DEVELOPMENT ASSESSMENT REPORT

Application No.	D/2019/354
Address	104 Foucart Street ROZELLE NSW 2039
Proposal	Alterations and additions to existing dwelling
Date of Lodgement	12 September 2019
Applicant	Steven Martin C/- Ahron Best Architects
Owner	Mr Steven A Martin Ms Natalia Gonzalez Londono
Number of Submissions	Two
Value of works	\$500,000.00
Reason for determination at Planning Panel	Clause 4.6 variations exceed 10%
Main Issues	Non-compliance with FSR, Site Coverage and Landscaping Rear Building location zone (BLZ) Extent of excavation Treatment around front ground floor window
Recommendation	Approval with Conditions
Attachment A	Recommended conditions of consent
Attachment B	Plans of proposed development
Attachment C	Clause 4.6 Exception to Development Standards

Figure 5: Proposed eastern elevation of dwelling

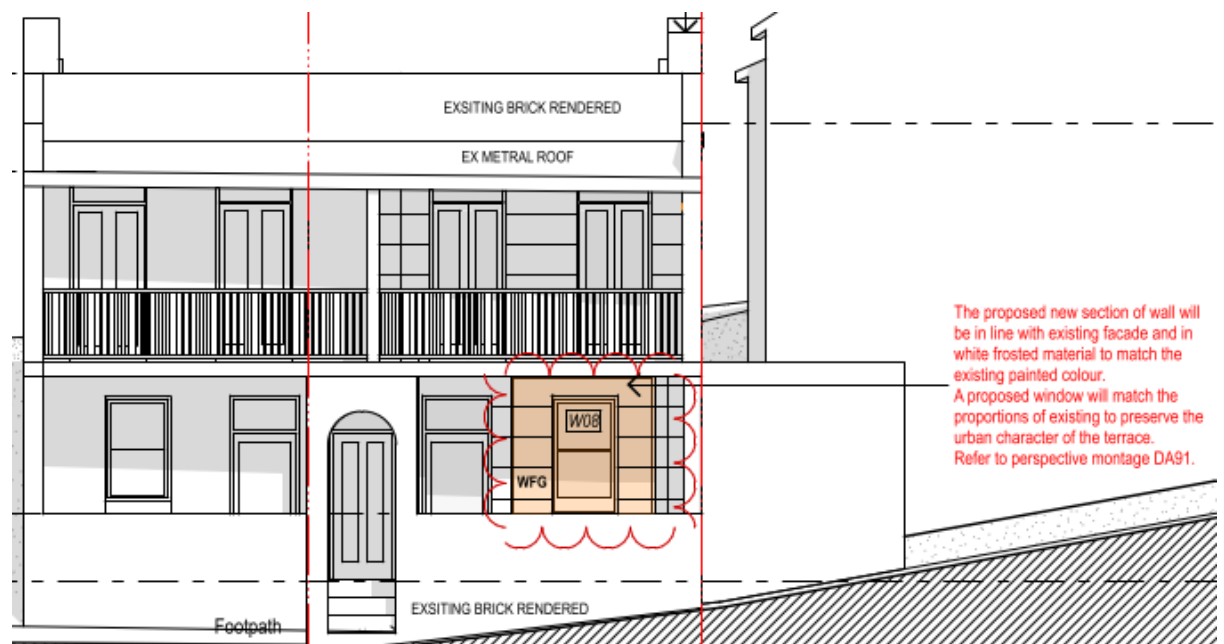
As also discussed under C1.3, C3.1 and C3.3 the changes to the ground floor front wall are not supported. The proposal includes changing the existing original ground floor front elevation and window which is currently a timber framed double-hung window which matches the adjoining dwelling which is a pair with No.102. The proposal is for a section of wall to be replaced with white frosted material around a window. The window is proposed to match the proportions of the existing window. Refer to Figure 5 below which shows the proposed changes to the eastern elevation.

- C1 *Preserve the existing varied styles of housing with special regard to the modest scale and simple, unadorned nature of the architecture.*
- C4 *Preserve the consistency and simplicity in built form, style and materials of the neighbourhood.*
- C13 *The use of traditional timber, stone or masonry finishes, iron roofing and timber windows is encouraged.*

Accordingly a condition is recommended that the proposed white frosted material around the window is deleted from the proposal and a double-hung window is retained within the existing window opening.
